THIS REPORT IS A FIELD STRUCTURAL SITE ANALYSIS OF THE EXISTING CONDITIONS OF THE NORTH ELEVATION UNDERLYING WYTHES OF MASONRY AFTER THE STONE VENEER REMOVAL. SITE ANALYSIS ALSO INCLUDED THE EXTG. CONDITIONS OF THE 2 X 12 ROOF RAFTER ASSEMBLY & RECOMMENDATIONS FOR REMEDIATION.

FIELD STRUCTURAL SITE ANALYSIS EVALUATION REPORT

SUBJECT PROPERTY: 35 N. BROADWAY, AURORA IL. 60505

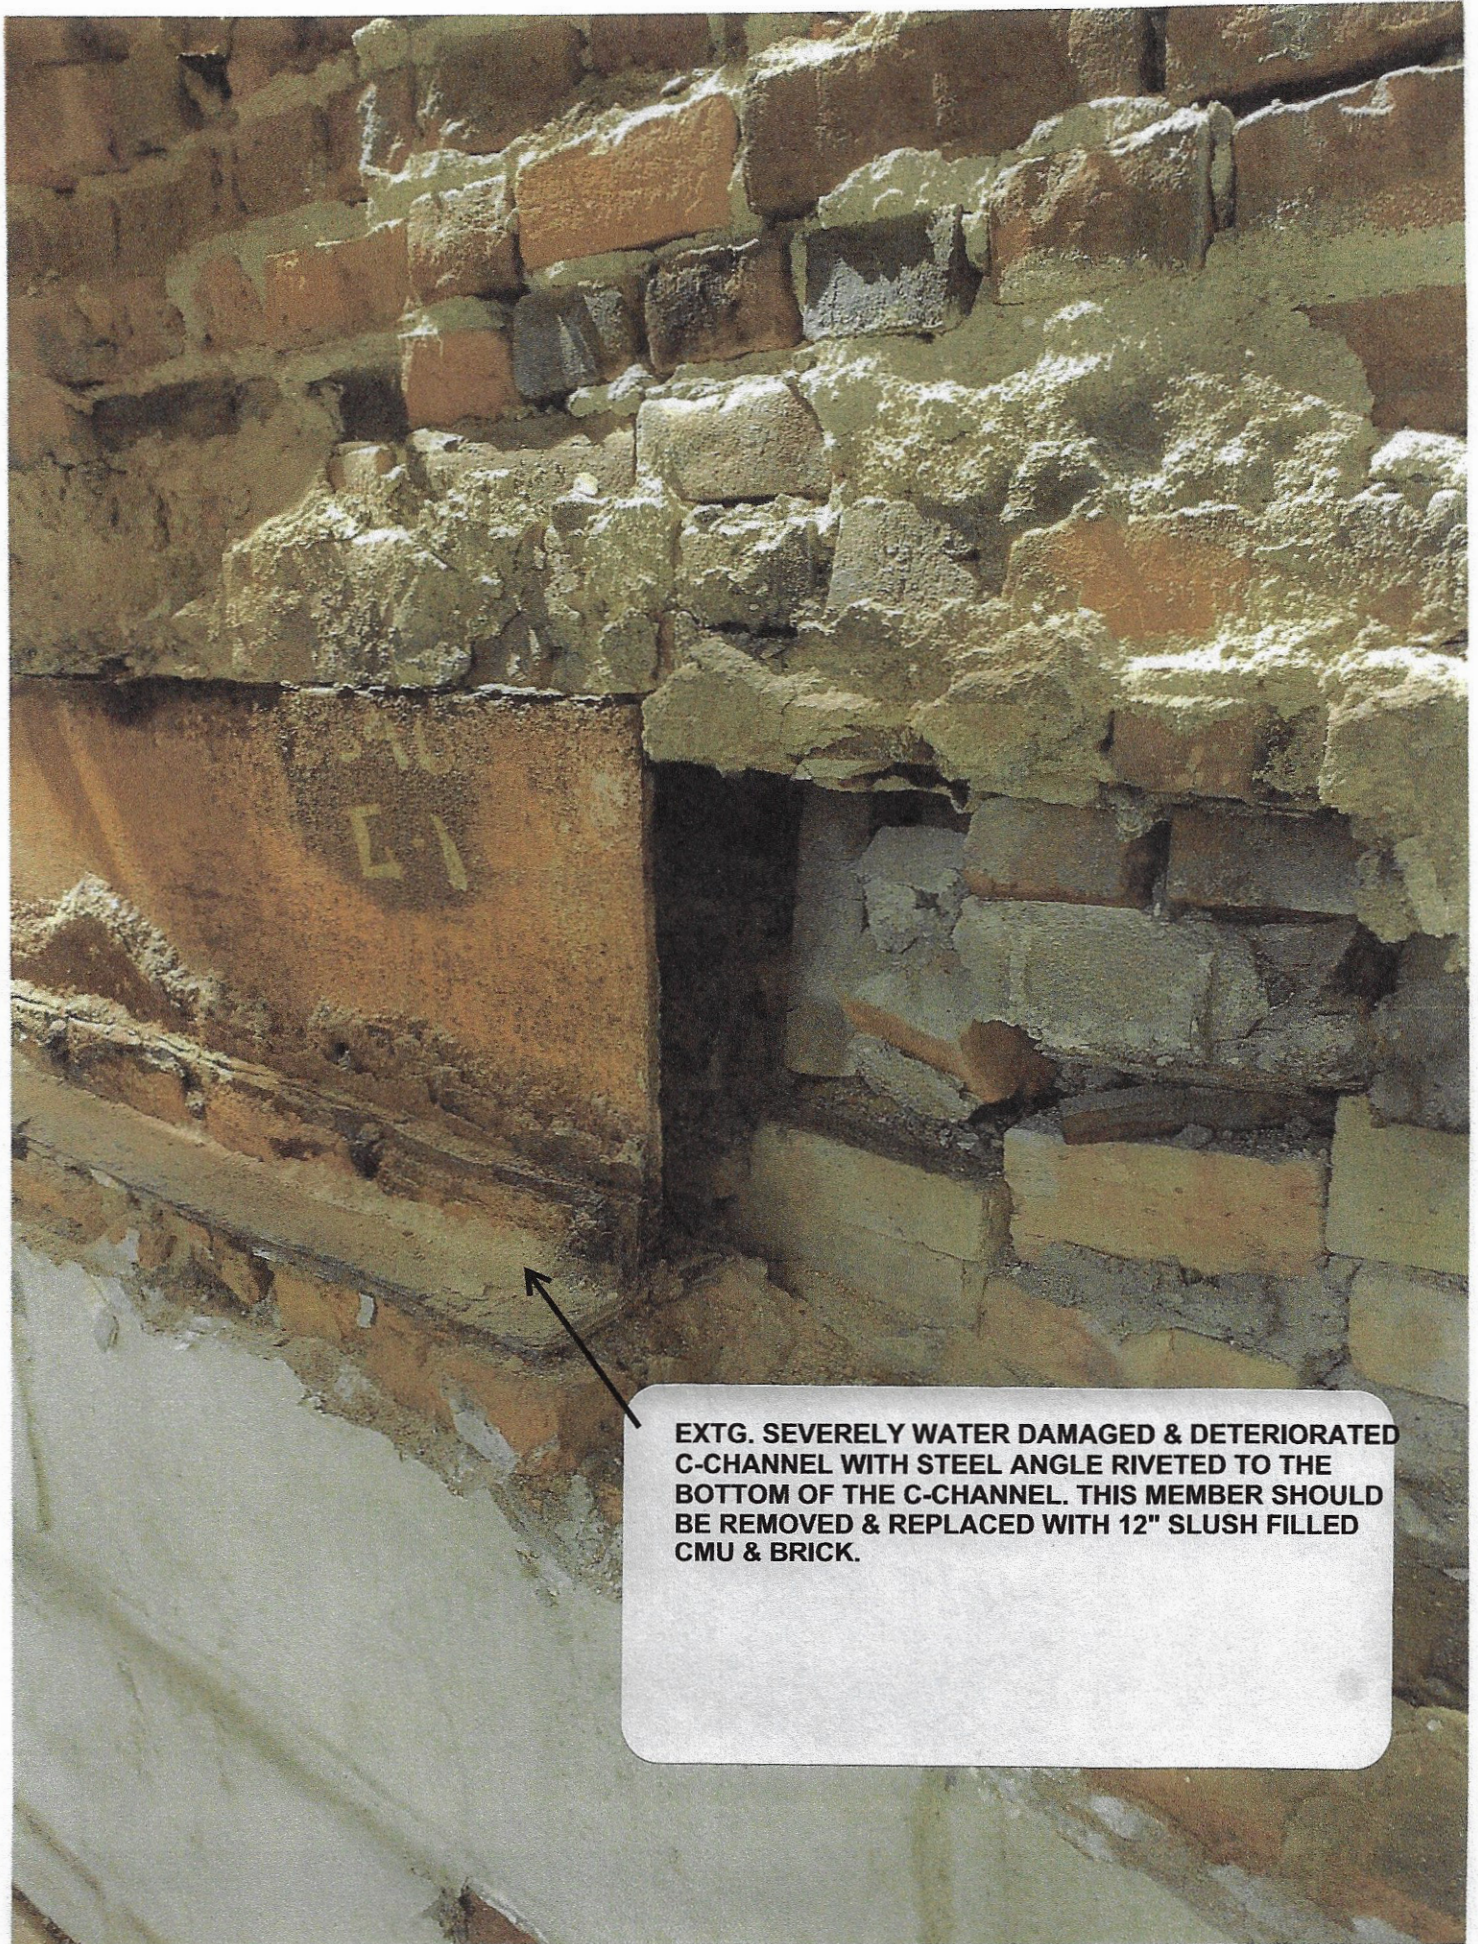
EXTG. CONDITION OF SEVERELY RUSTED, WATER DAMAGED C-CHANNEL WITH STEEL ANGLES RIVETED TO THE BOTTOM OF THE C-CHANNEL. WE ARE RECOMMENDING TO INCREMENTAL REMOVE ALL STEEL LINTELS SHOWN AT THE TOP OF THIS 1ST FLOOR ELEVATION, AND REPLACE WITH BRICK & 12" SLUSH FILLED CMU.

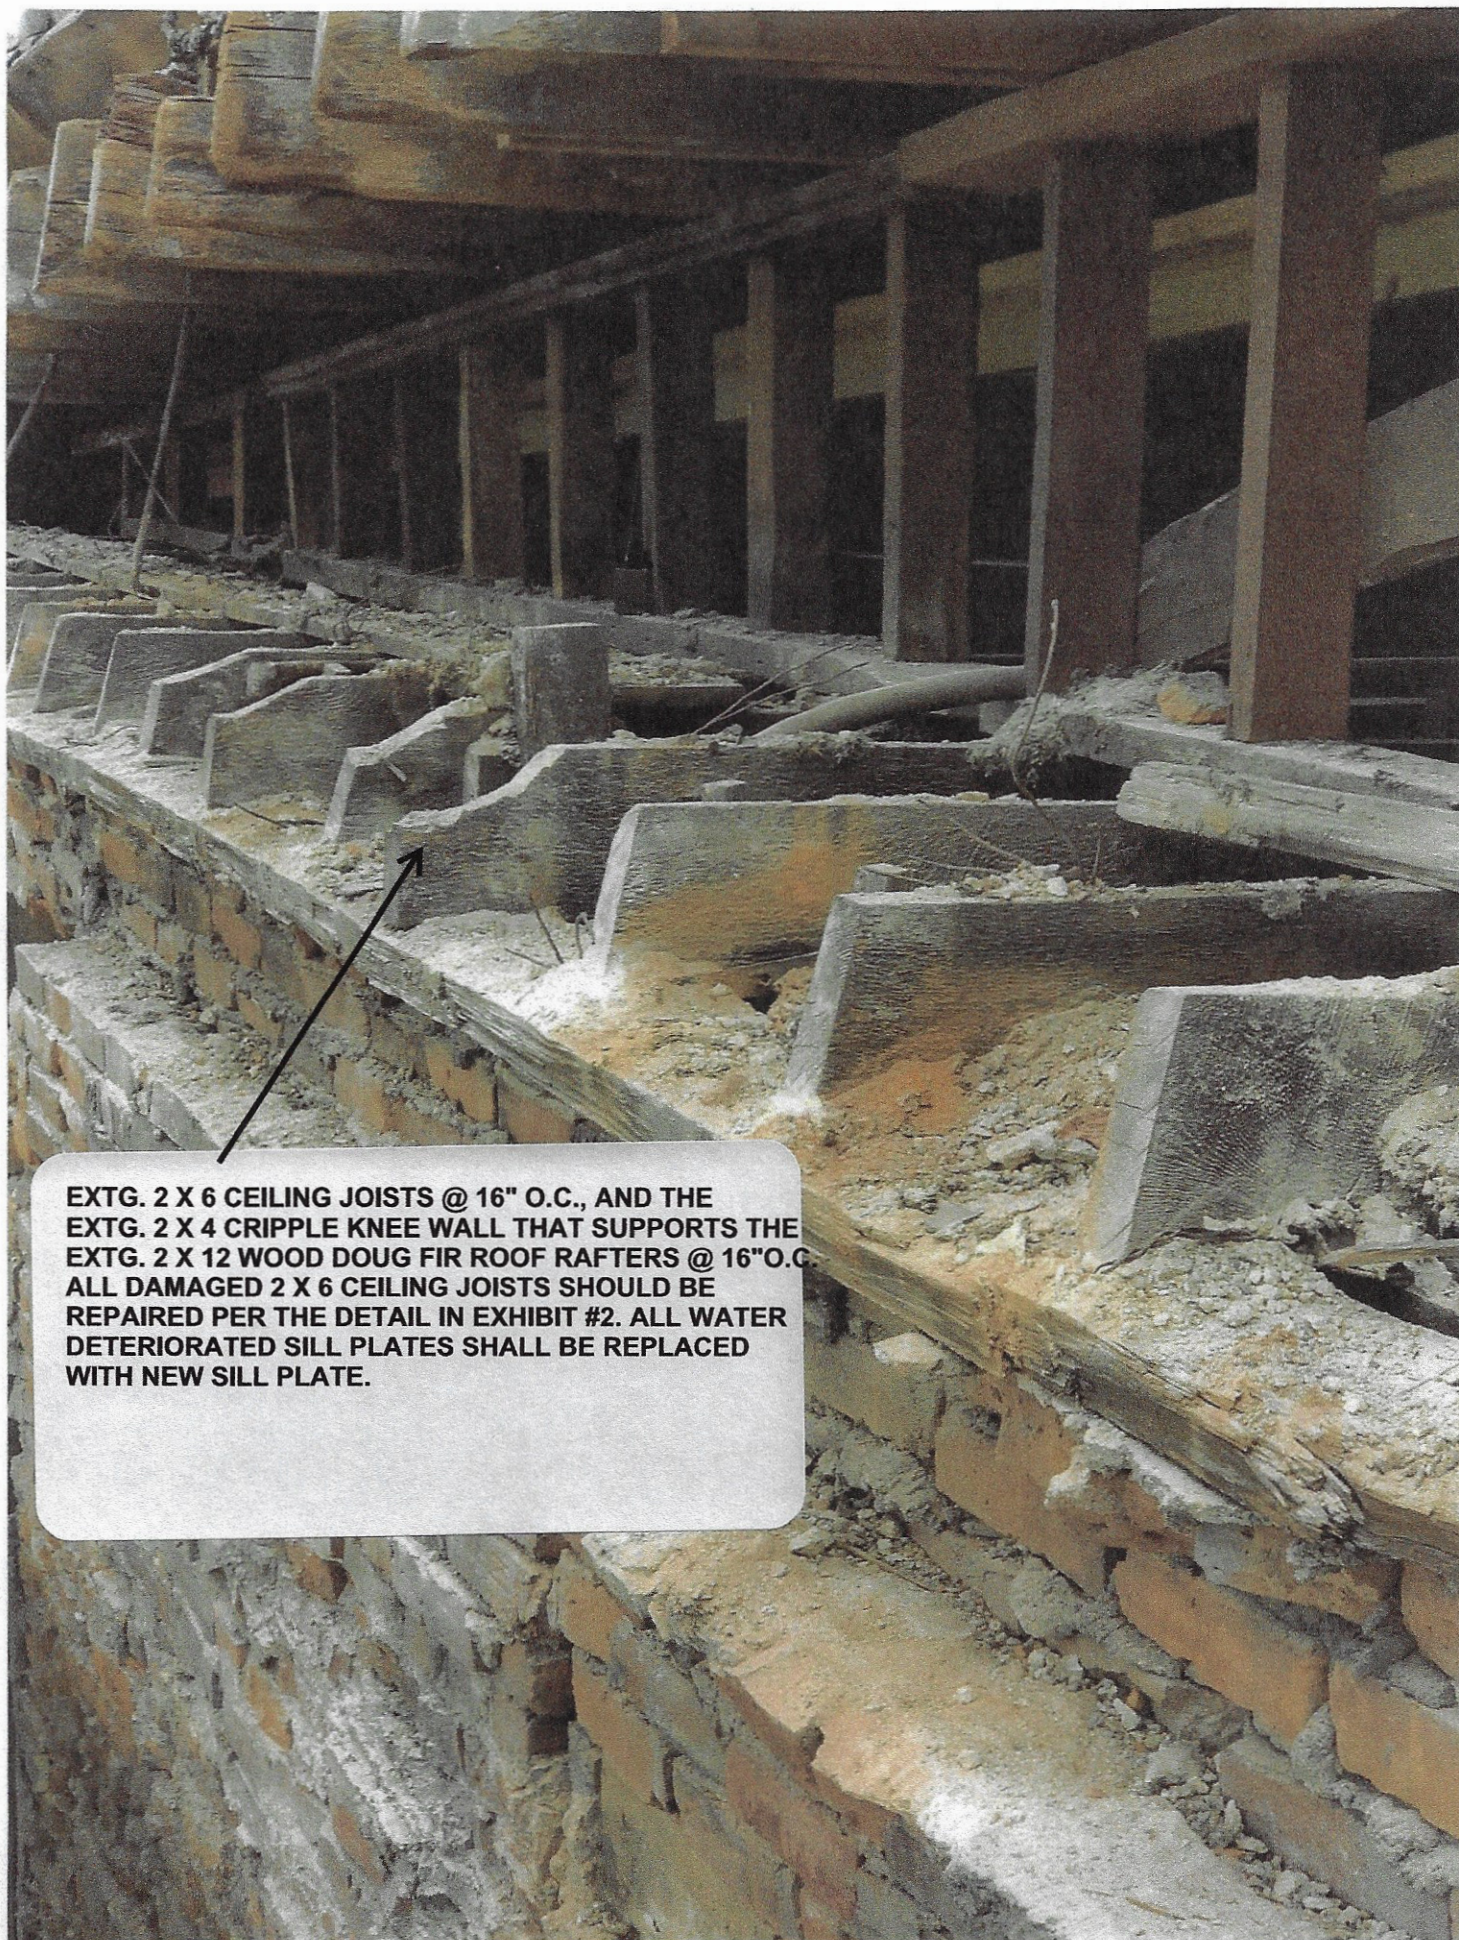
EXTG. STEEL C-CHANNEL SEVERELY WATER DAMAGED AND RUSTED. REMOVE & REPLACE WITH 12" CMU SLUSH FILLED & BRICK.

EXTG. SEVERELY WATER DAMAGED & DETERIORATED C-CHANNEL WITH STEEL ANGLE RIVETED TO THE BOTTOM OF THE C-CHANNEL. THIS MEMBER SHOULD BE REMOVED & REPLACED WITH 12" SLUSH FILLED CMU & BRICK.

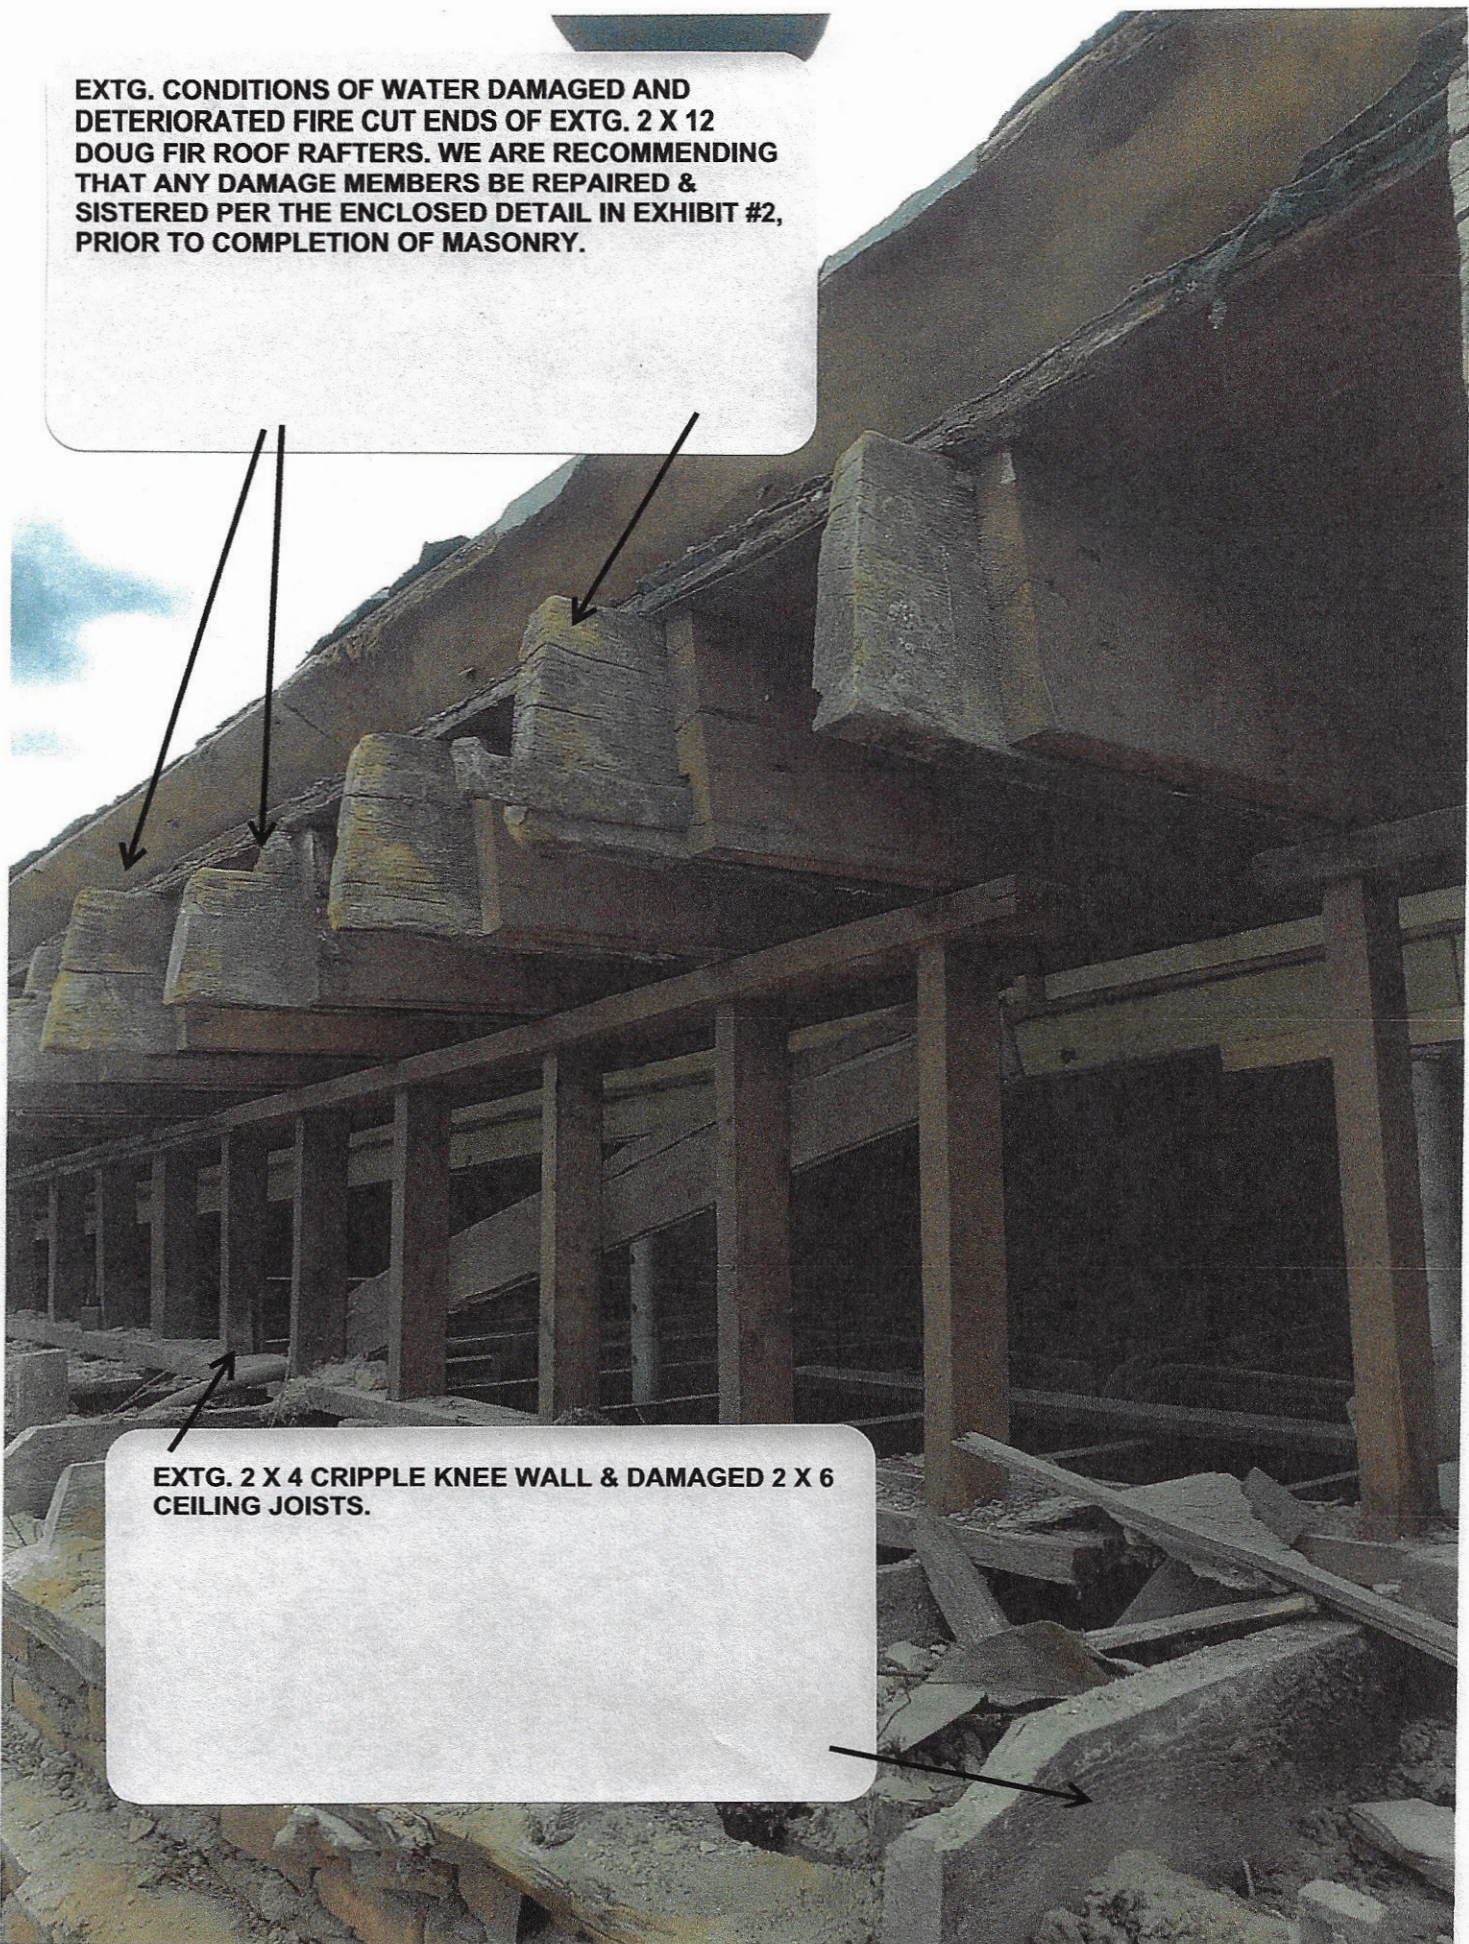
EXTG. WOOD WINDOW LINTEL IN SEVERAL LOCATIONS. WE ARE RECOMMENDING THAT ANY WATER DAMAGED WOOD LINTEL SHOULD BE REPLACED WITH A NEW STEEL LINTEL. IT SHOULD BE REPLACED WITH A NEW W8 X 18 WITH A NEW 3/8" X 14" PLATE WELDED TO THE BOTTOM FLANGE OF THE W8 X 18. SEE CALCULATIONS IN EXHIBIT #1.

**EXTG. 2 X 6 CEILING JOISTS @ 16" O.C., AND THE
EXTG. 2 X 4 CRIPPLE KNEE WALL THAT SUPPORTS THE
EXTG. 2 X 12 WOOD DOUG FIR ROOF RAFTERS @ 16" O.C.
ALL DAMAGED 2 X 6 CEILING JOISTS SHOULD BE
REPAIRED PER THE DETAIL IN EXHIBIT #2. ALL WATER
DETERIORATED SILL PLATES SHALL BE REPLACED
WITH NEW SILL PLATE.**
